**Rover Service News Letter No. 116**

June 1960.

**TO ALL DISTRIBUTORS AND DEALERS**

Fig. 1. Fitting retainer halves and oil seal.

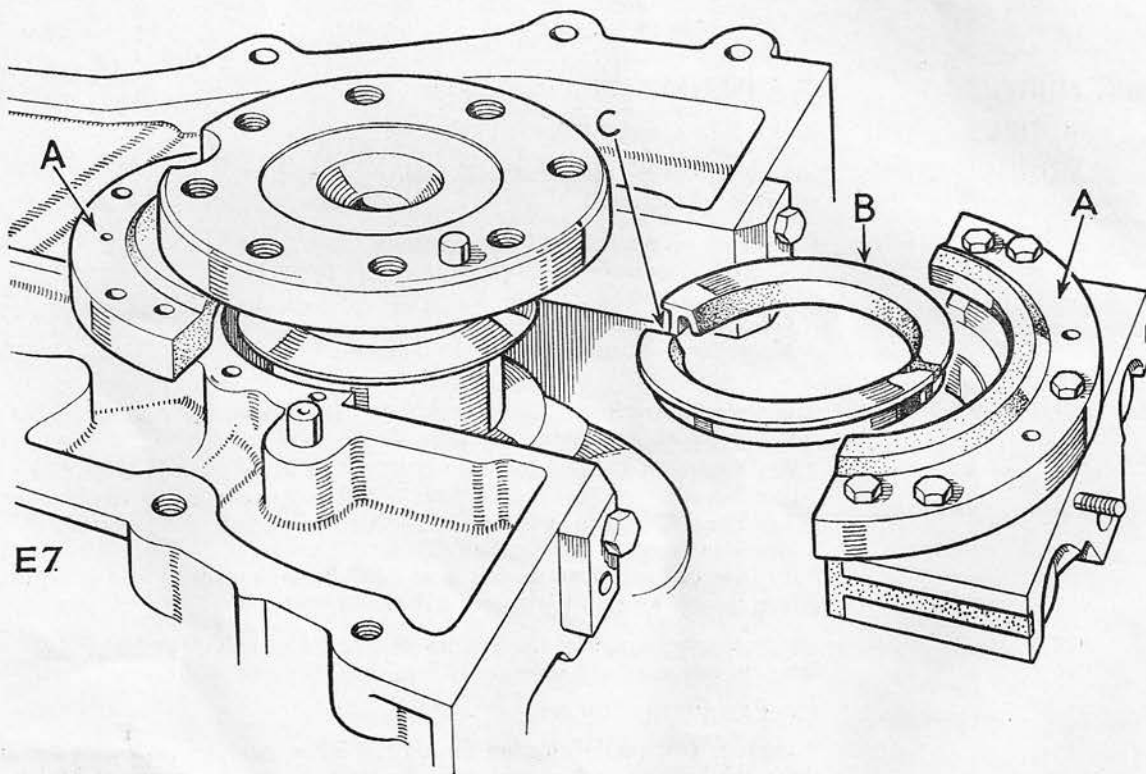
Improved design crankshaft oil retainer, comprises two retainer halves with separate split oil seal.

The latest type crankshaft retainer and seal assembly Part No. 518427 can be fitted to any earlier 3 litre or '100' model; proceed as follows:

1. Apply Silicone grease MS4 Part No. 270656 liberally to both sides of the split oil seal rubbing face.
2. Open the split oil seal sufficiently to allow it to be fitted over the crankshaft oil seal journal. The rubber ribs on the inside of the seal should be facing the crankshaft thrust collar. The split line on the seal should be pointing towards the top of the cylinder block. The oil seal must not be repeatedly fitted and removed from the crankshaft, as this can damage the sealing lip.

3. Slide the split oil seal along the journal until it is nearly touching the crankshaft flange.
4. Fit one half of oil seal housing on to the crankcase dowels. The split oil seal should be compressed to assist assembly.

5. Bolt the housing firmly on to the crankcase, tightening all five bolts fully. It will be necessary to rotate the crankshaft on 3 litre engines due to the 5 in. (127 mm) flange, therefore the split oil seal should be held to prevent it rotating with the shaft.

6. Bolt the other half of the oil seal housing firmly on to the main bearing cap, tightening all five bolts fully.
7. Fit the main bearing cap with the seal housing, bearing shell half and packing for main bearing cap to the crankcase. Smear side seals with Silicone Grease M.S.4 and use special tool Part No. 270304 to assist assembly. Do not fully tighten at this stage.

8. Using two screwdrivers, slide the split oil seal along the shaft until its flange is flush with both the top and bottom oil seal housing halves. It is essential that care is taken to ensure that there is no buckling of the split oil seal or misalignment of the split joint. On 3 litre models the joint can be inspected by rotating the crankshaft until the cut-out in the flange is adjacent to the split in the oil seal.
9. Pull the main bearing cap down to the correct torque, that is 65 lb/ft. (9 mkg), ensuring that the split oil seal does not move.

Fig. 3. Cross-section of rear hub.

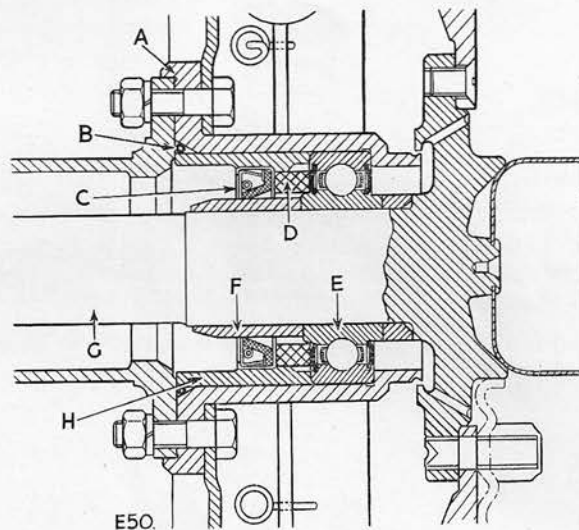
The latest type bearing housing for rear wheel can be used on all earlier '80', '100' and 3 litre models, and 1948-59 '60', '75', '90' and '105' models. The 'O' ring and felt seal can be fitted to these models in conjunction with the sleeve for oil seal and the bearing housing for rear wheel.

Alternatively, the original bearing housing can be modified; full instructions together with all the parts required, are supplied under Rear hub sealing modification kit Part No. 520808.

Fig. 4. Layout of over-centre clutch linkage

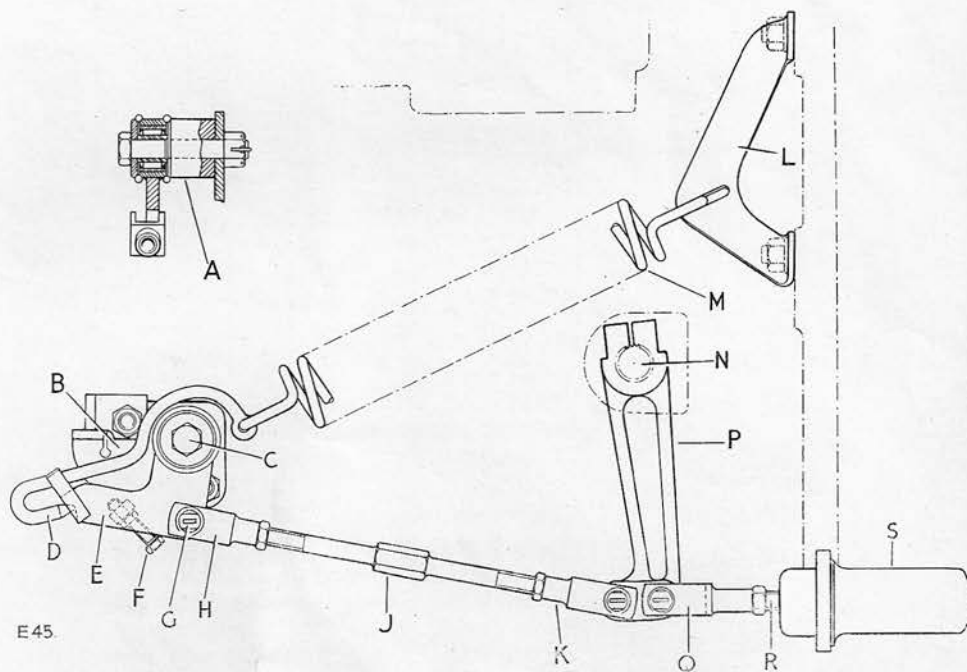
REMARKS: The complete adjustment of the clutch and over-centre linkage on the Rover 3 Litre models should be carried out as follows:

1. Disconnect clevis K and Q from clutch lever P.
2. Rotate clutch cross-shaft N in a clockwise direction, as far as possible, to ensure that all clearance between the clutch withdrawal sleeve and release levers is taken up.
3. With the cross-shaft end held in the fully clockwise direction, the clutch lever P must be fitted one spline forward of the vertical position.

4. With the slave cylinder push rod R pushed as far as possible into the bore of the cylinder, and the clutch lever P still held one spline forward of the vertical position, adjust rod R so that when the clevis is connected there is approximately  $\frac{3}{32}$  in. (2,5 mm) of free play. This adjustment will give the correct pedal free play and the correct clearance between the clutch withdrawal sleeve and release levers.

5. Unscrew adjusting bolt F a few turns.
6. Reconnect clevis K to lever P and adjust length of rod so that the clevis pin G is vertically in line with the pivot bolt C.

7. Whilst the clutch pedal is held fully depressed, adjust bolt F so that it abuts on to the stop plate, then tighten the lock-nut. This adjustment prevents the linkage from going over-centre and thus ensures that the clutch does not stick in the disengaged position.

8. Depress the clutch pedal a few times to ensure correct operation of linkage.
9. When routine clutch pedal free play adjustment is carried out, any adjustment of the clutch slave cylinder push rod R must be compensated by adjustment of rod J. For example, if adjustment at rod R is shortened by two turns, then the adjustment at rod J must be lengthened by **one turn only** to maintain the vertical position of the pivot bolt C and clevis G.

Fig. 5. Position of coat hook on '80' and '100' models  
 A—Centre line of 'B-C' post  
 B—4½ in. (104 mm)  
 C—1½ in. (31 mm)  
 D—Front of car

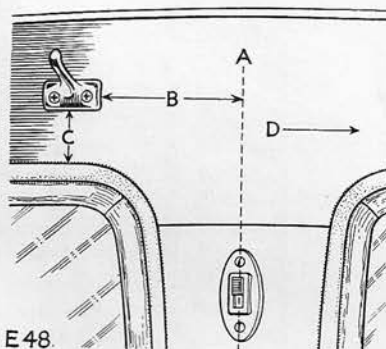
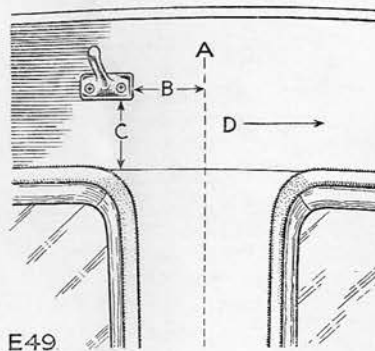
MODIFICATION: Introduction of coat hook fitted above the 'B-C' post.

REMARKS: Coat hooks can be fitted to any earlier '80', '100' and 3 Litre models. For location see illustrations.

Fig. 7. Wind deflector fitted in position

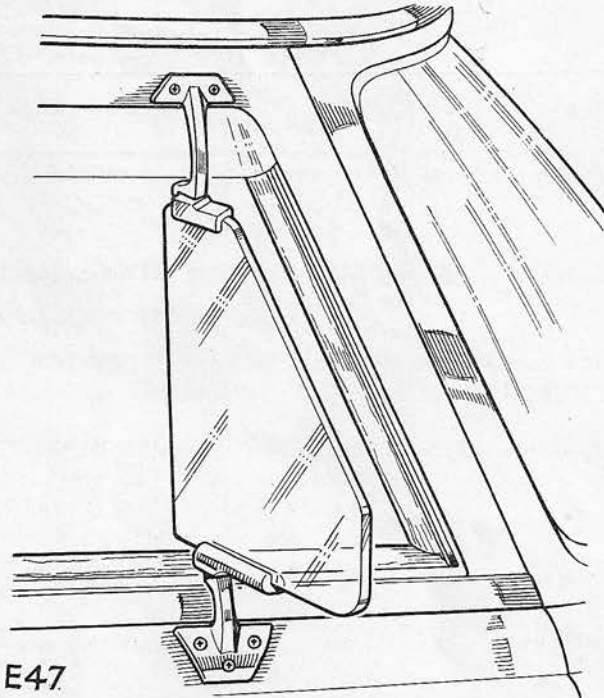
**MODIFICATION:** Introduction of wind deflector fitted adjacent to front door windows.

**REMARKS:** Wind deflectors are supplied as a kit, complete with Fitting Instructions, under Part No. 357060. They are designed to deflect additional cool air into the car and can be fitted to any Rover 3 Litre model.
